IREDELL COUNTY HEALTH DEPARTMENT

IMPROVEMENT PERMIT / AUTHORIZATION TO CONSTRUCT / OPERATION PERMIT / EXISTING SYSTEM INSPECTION

PERMIT# 074451 PIN# 4639368898 4635-36-9815 Dave DATE 5/21/03

SUBDIVISION Clay BLOCK / SECTION 5 LOT 34 LOT AREA 1.67 Acre SITE CLASS PS DESIGN FLOW 600gpd L.T.A.R. .3

INITIAL SITE SKETCH Scale 1:60

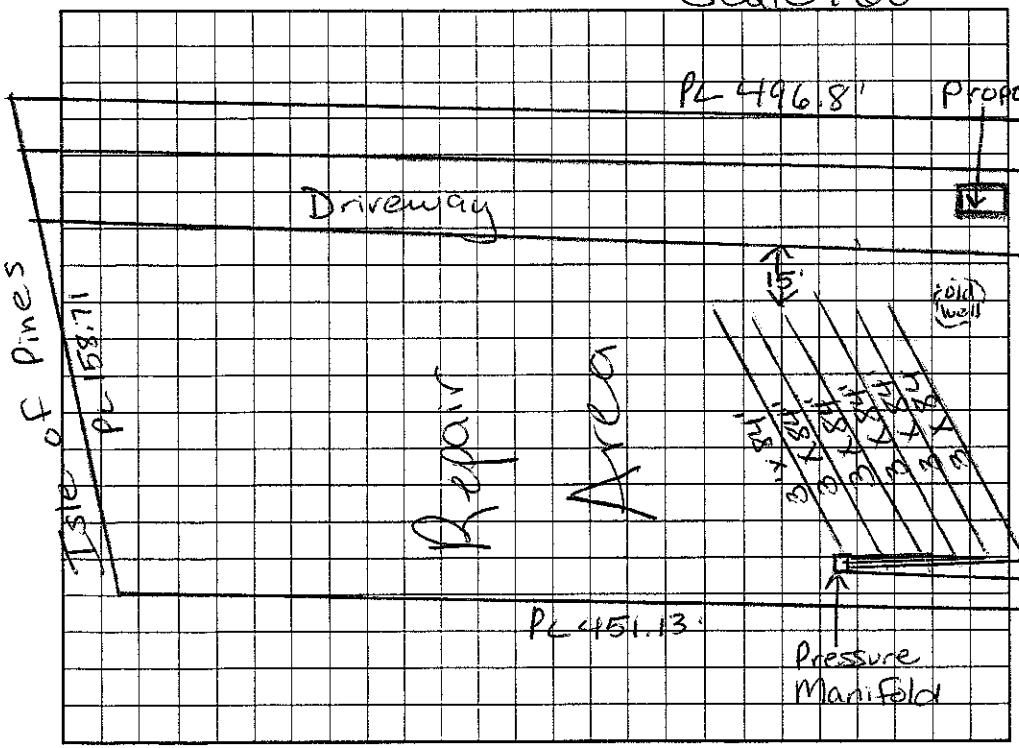
Comments:/Conditions: Keep Septic System at least 10' from PL, 50' from lake & 100' from well. Note: Soil in tank pit looked like CL until close to bottom of pit.

Comments:/Conditions: Note: Keep Drainlines 15' from driveway cut.
[X] Must "properly abandon" old well prior to Septic System installation.

AS BUILT SKETCH

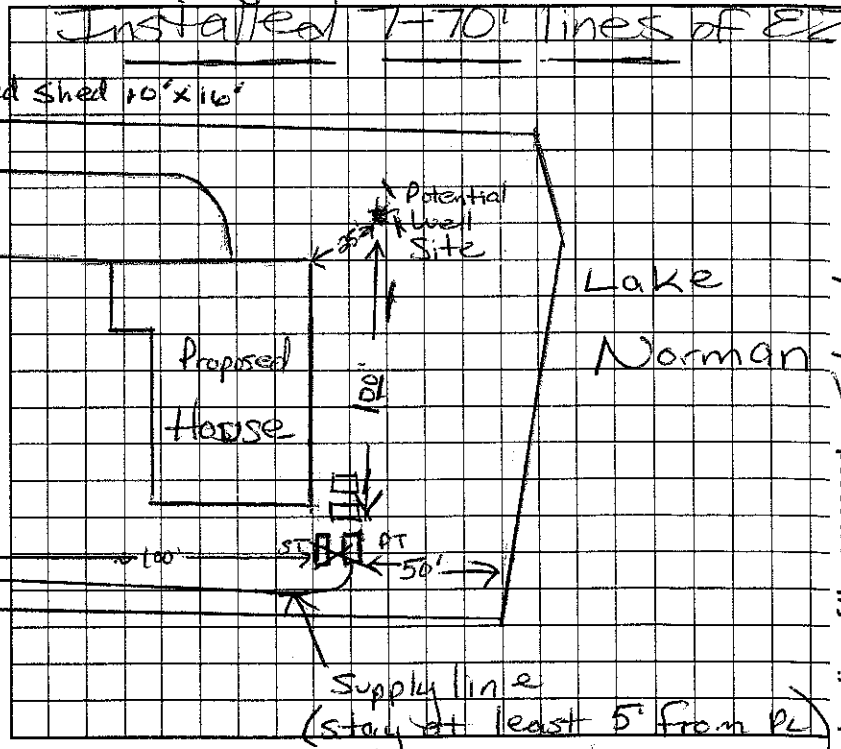
Installed 7 +70' lines of EZ Flow

The location of the proposed Shed addition does not appear to impact the existing septic system.
